PETITION FOR SPECIAL EXCEPTION

The undersigned, legal owner(s) of the property situate in Baltimore County and which is described in the description and plat attached hereto and made a part hereof, hereby petition for a Special Exception under the Zoning Law and Zoning Regulations of Baltimore County, to use the herein described property for _____ Class B Office Building in R-O Zone _____

SPODAK OFFICE BUILDING

PROJECT NAME: Spodak Office Building
PROJECT NUMBER: 85079
LOCATION: 1018 Dulany Valley Road
DISTRICT: 9C4

PROPOSED ALTERATIONS FOR DOCTOR'S OFFICE

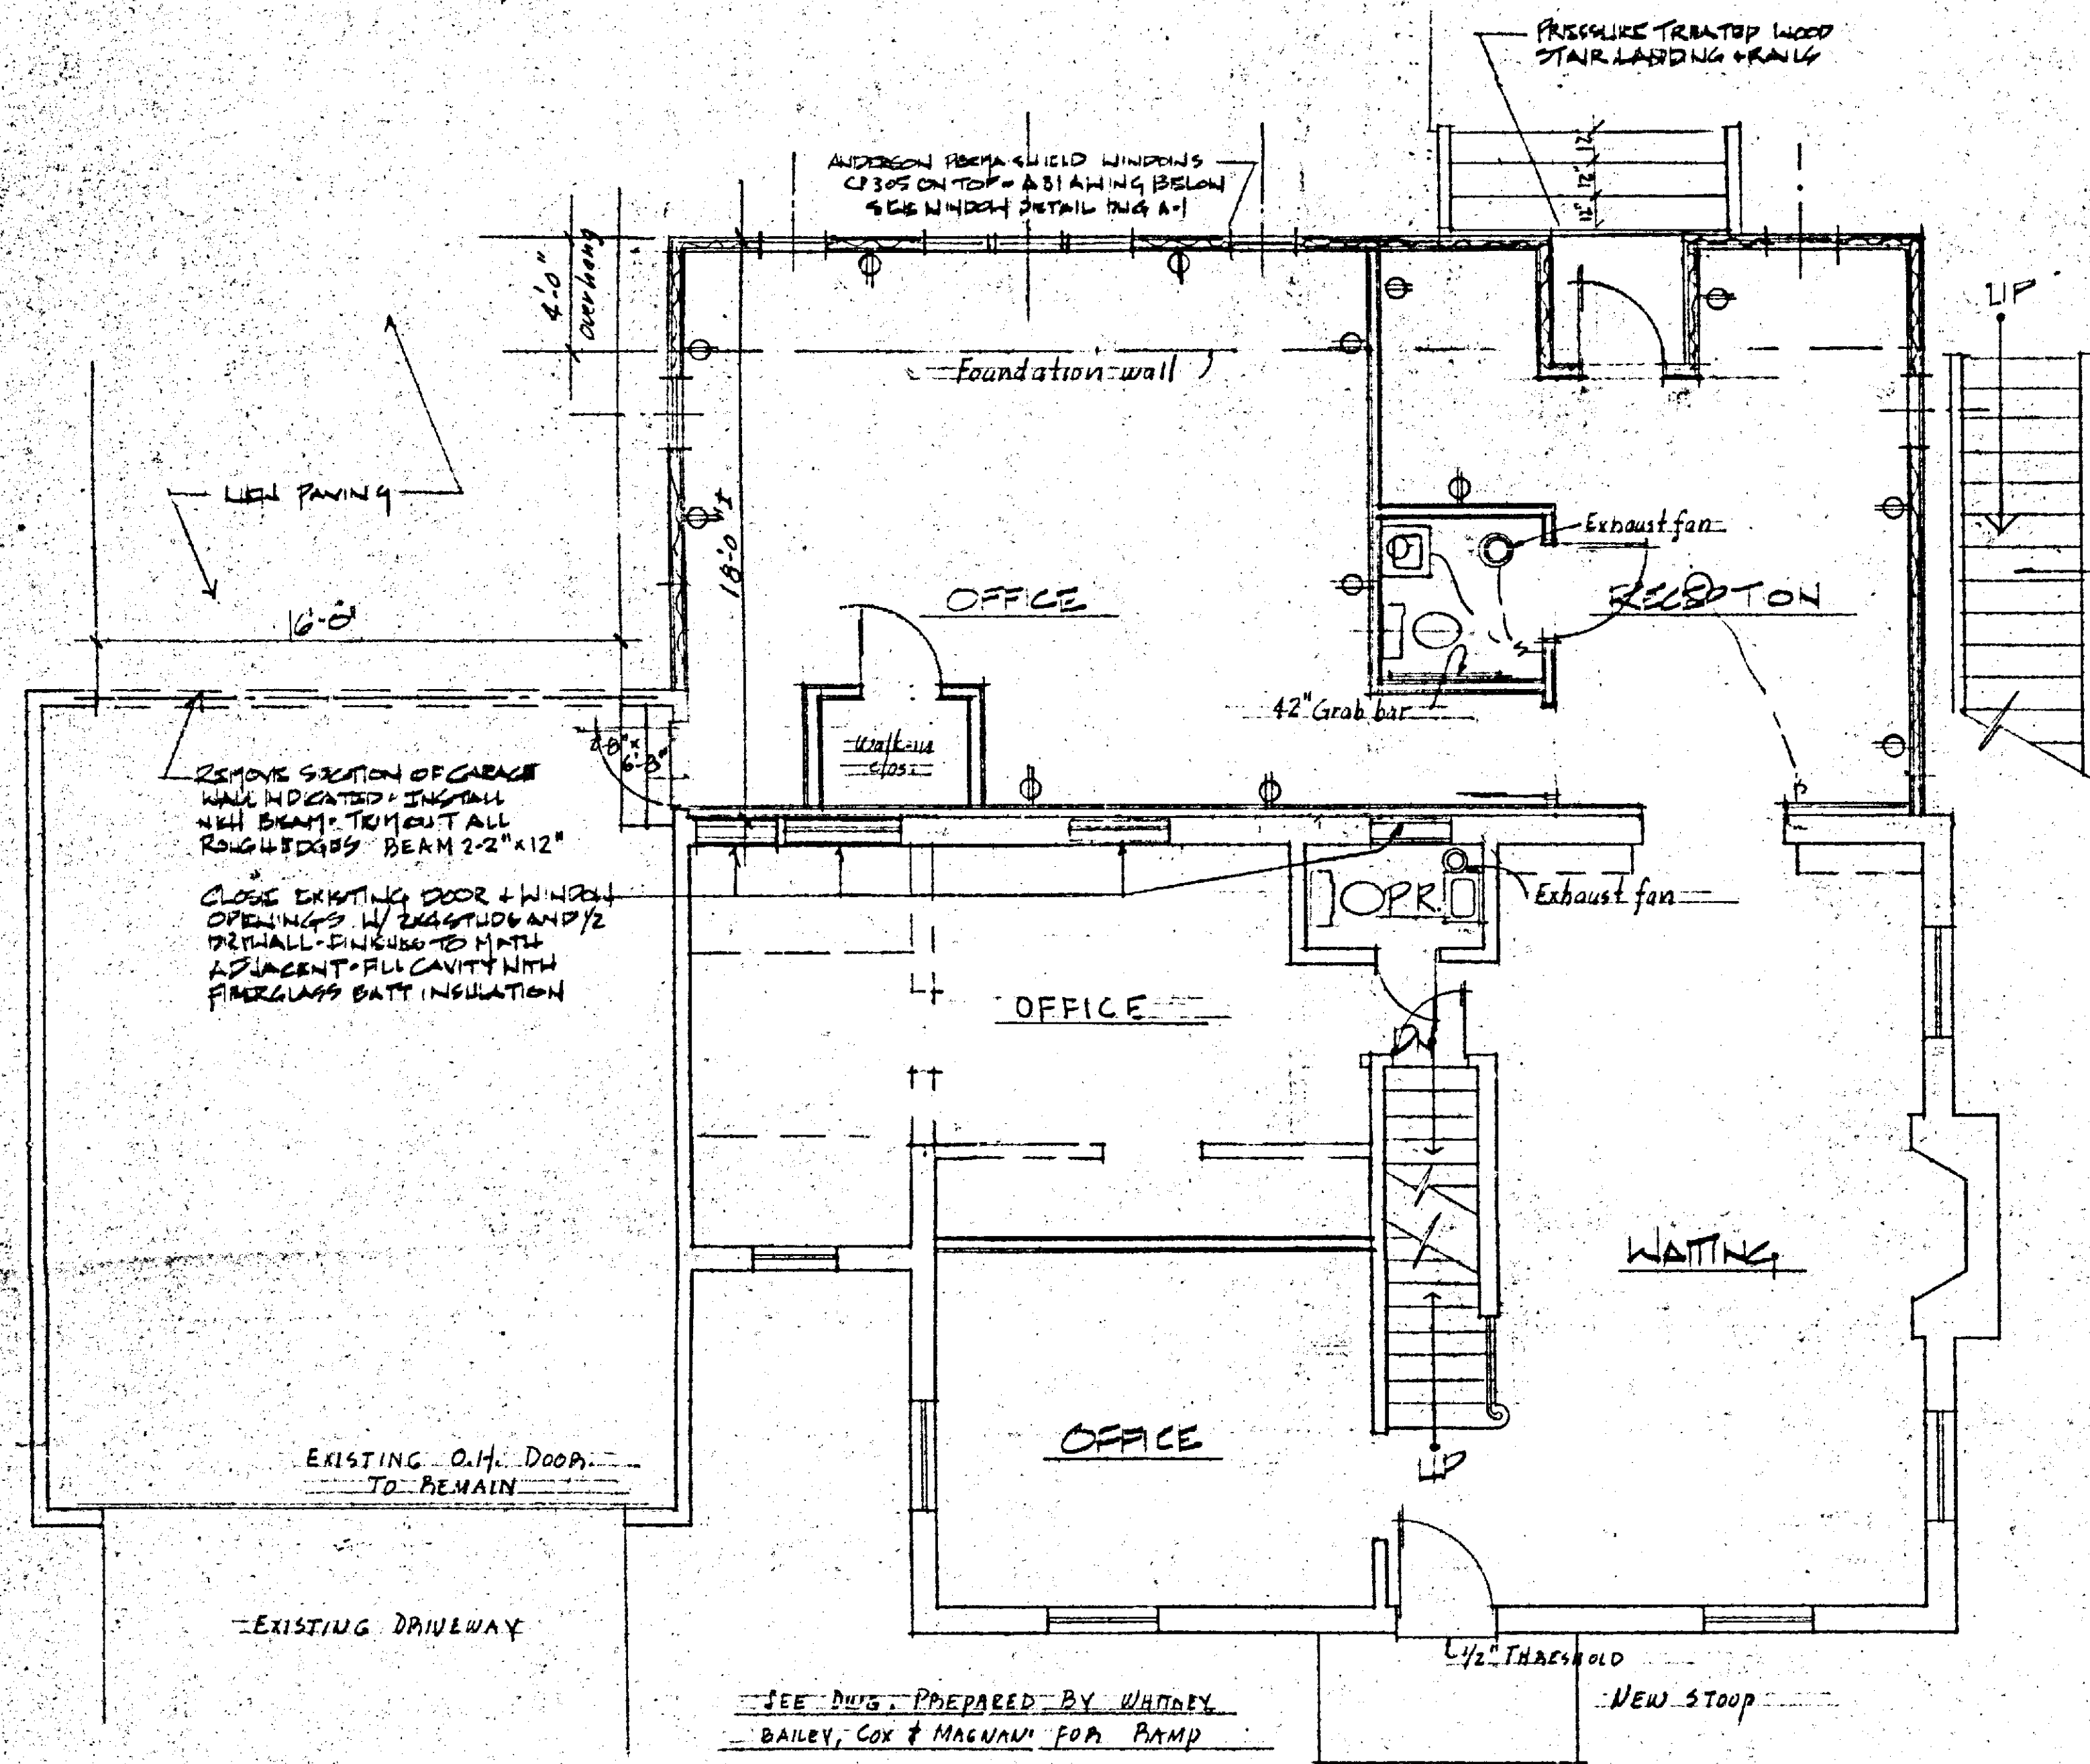
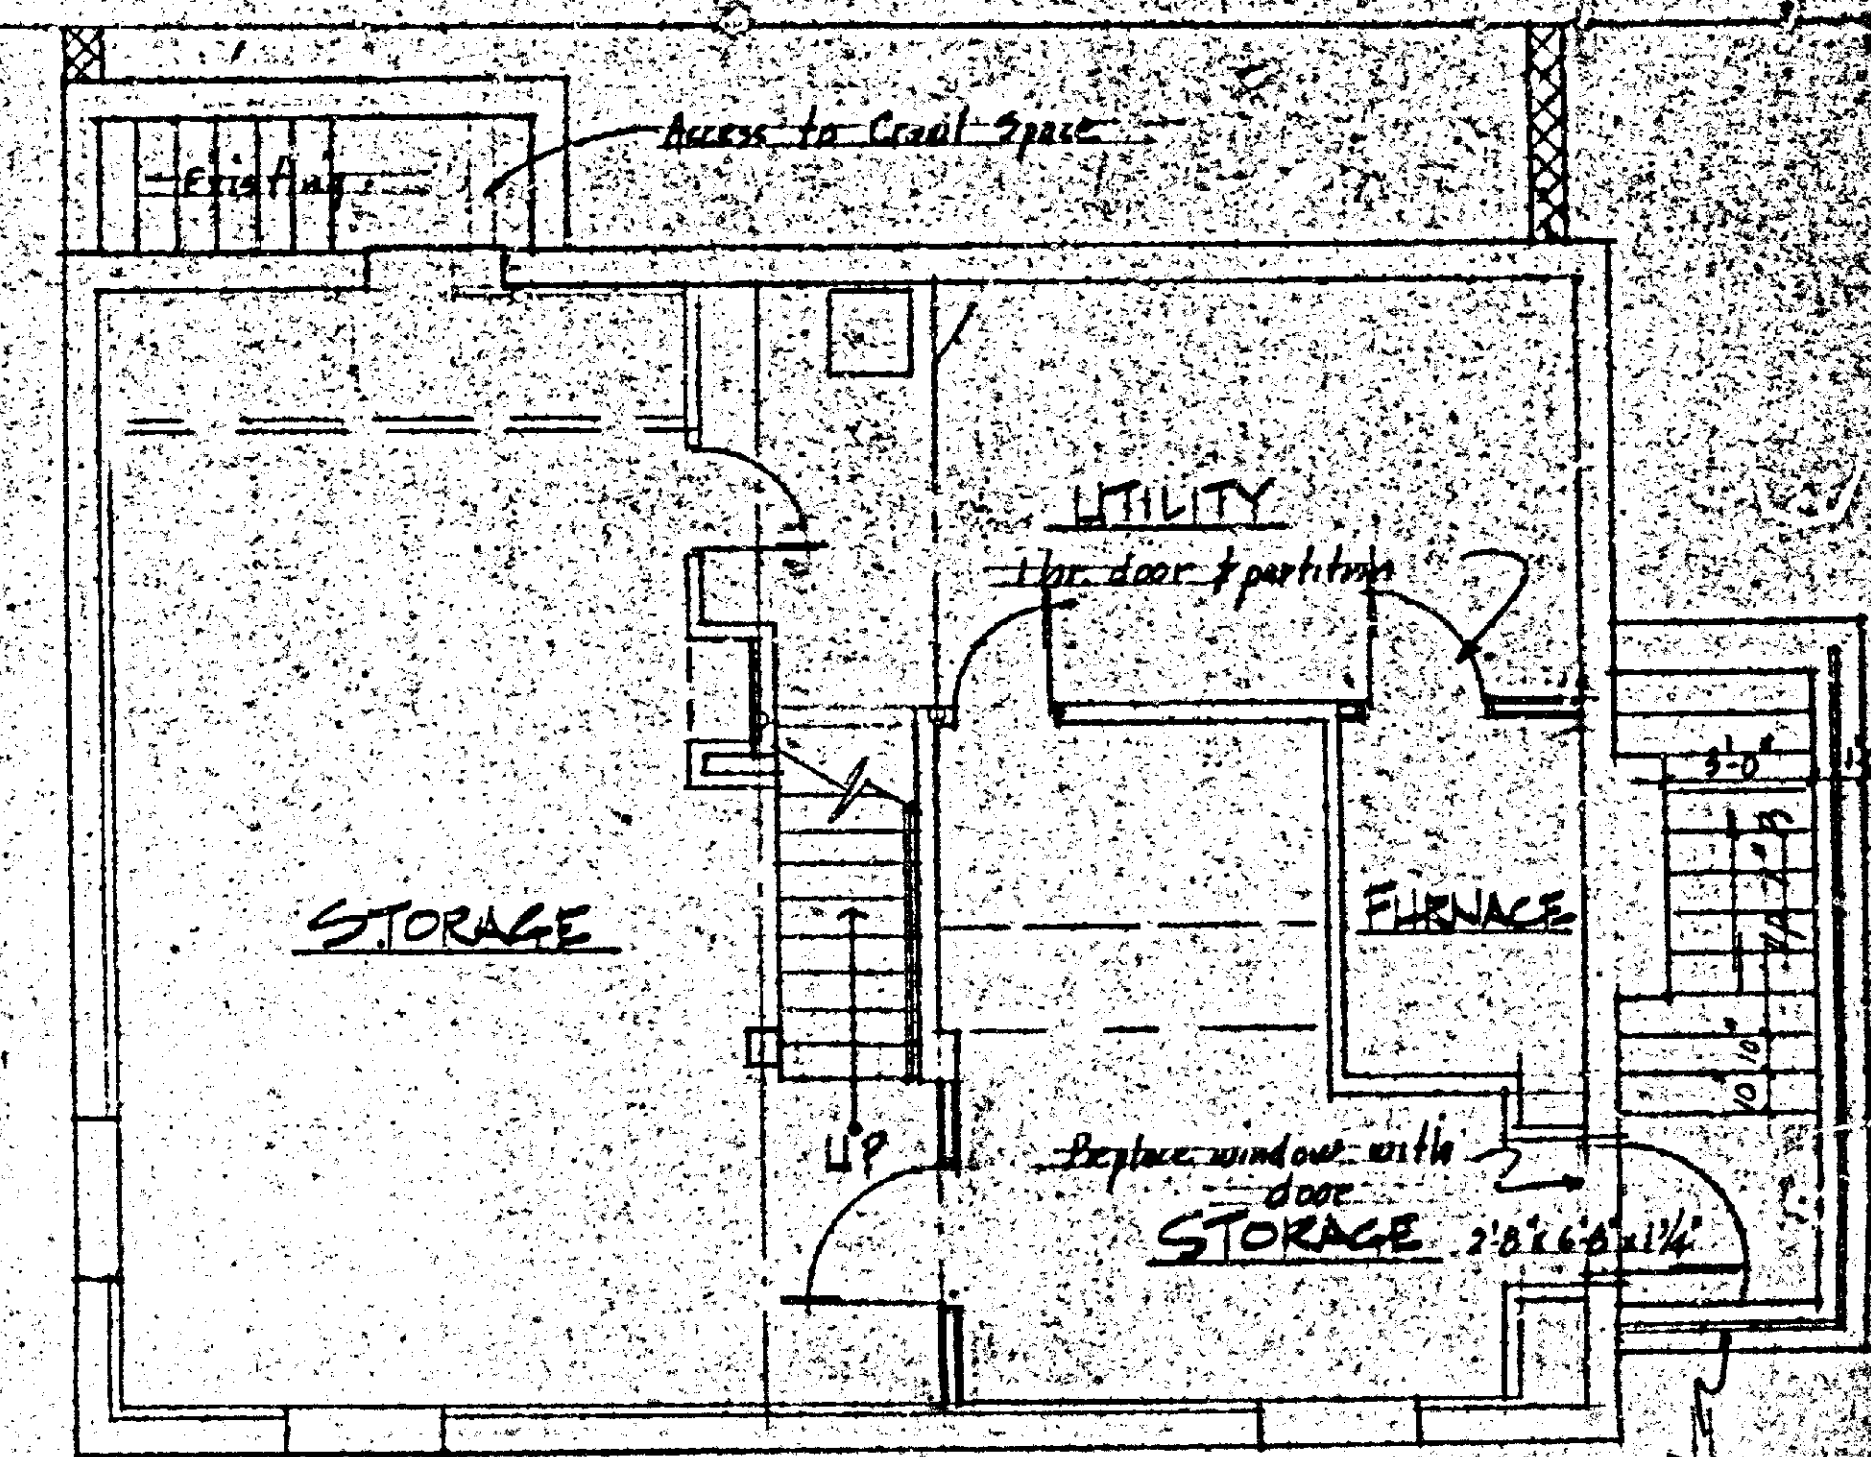
F. The structure does not appear to comply with Table 505 for permissible height/area. Reply to the requested variance by this office cannot be considered until the necessary data pertaining to height/area and construction type is provided. See Table 401 and 505 and have your Architect/Engineer contact this department.

- (✓) 1. A change of occupancy, alteration, and other miscellaneous permits are required.
- (✓) 2. Floor loading of 50 pounds live load design are required. Have a registered in Maryland structural engineer provide a letter of certification. See Section 903.0, 904.0, 905.0, Table 906.0, 907.0.

- (✓) 8. Exit stairs, handrails, etc. shall comply with Section 816.0.
- (✓) 9. Plan does not show the following handicapped requirements under the State Handicapped laws:
